Date: May 6, 2008
 To: T10 Technical Committee
 From: Alvin Cox (alvin.cox@seagate.com)
 Subject: SAS-2 letter ballot comment updates for transmitter and receiver tables

Abstract: The attached information is a result of discussions concerning letter ballot comments on SAS-2 related to the 6Gbps transmitter device, reference transmitter, and physical receiver testing.

Figure xxx – Delivered eye opening

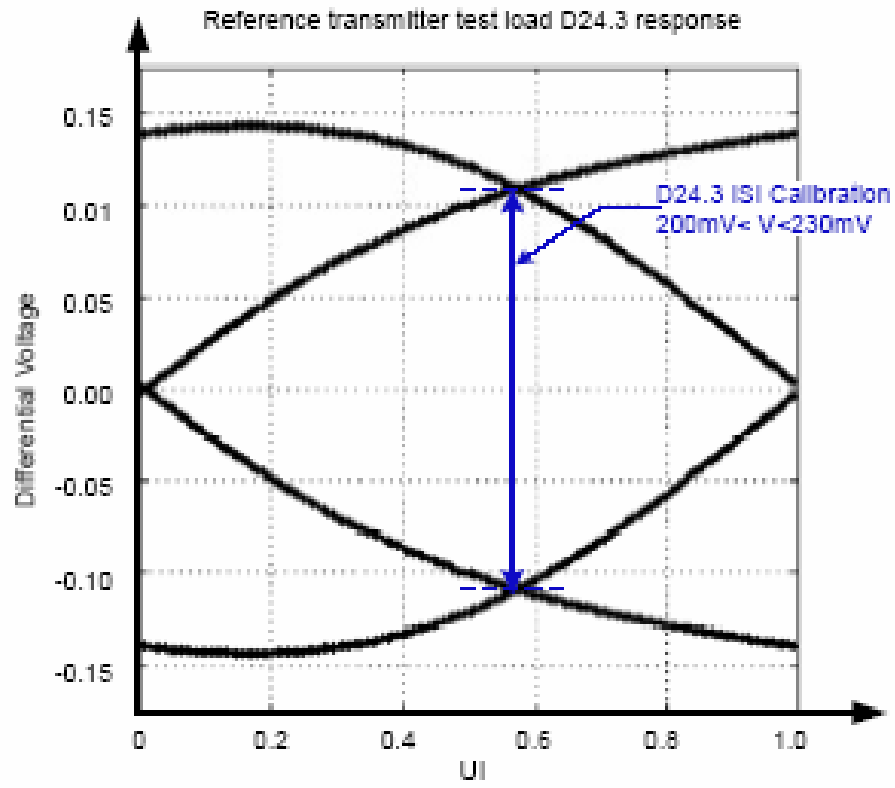
- a Link dispersion penalty is the WDP of the delivered signal computed with Palloc = 15.4 dB.
 b This ~~specification value~~ pertains to the delivered signal at IR or CR during the receiver device compliance test. All adjacent phys in the receiver device shall be active with representative traffic with their maximum amplitude and maximum frequency of operation. Additional pseudo-random crosstalk shall be added, if needed, to meet the total crosstalk amplitude specification.
 c Observed with a histogram of at least 1 000 ~~hits~~ samples.
 d Bounded uncorrelated jitter (BUJ) is the part of the deterministic jitter not aligned in time with the data signal being measured. Specifically, this excludes ISI and DCD. See MJSQ.
 e An SSC modulated source may be used instead of fixed offset frequency crosstalk.
 f Based on the centroid of the vertical histogram at 1 and 0 crossing (see Figure xxx)
 g Nominal values represent target settings for configuration of the test setup. If minimum and maximum values are also included, the test setup value shall be within this range (i.e., a range is required when using physical implementation), however, these ranges shall not be used as corner test conditions required for specification compliance.
